ADA Curb Ramp New Construction Inspection Form (Perpendicular)

Nw 292nd

23885.56

Nw fair

PERPENDICULAR RAMP (PR)

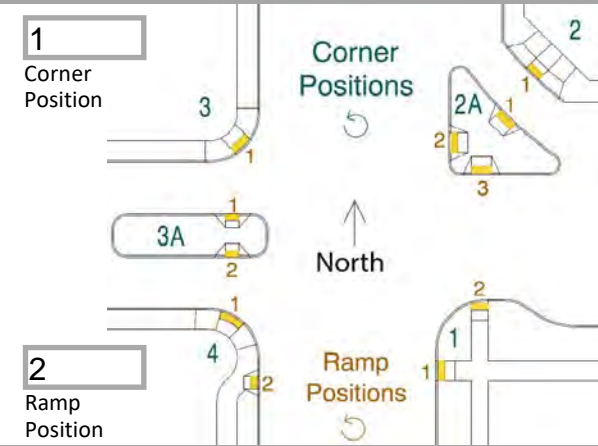
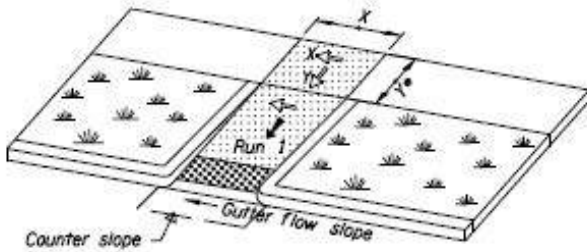
Tool joints in TS
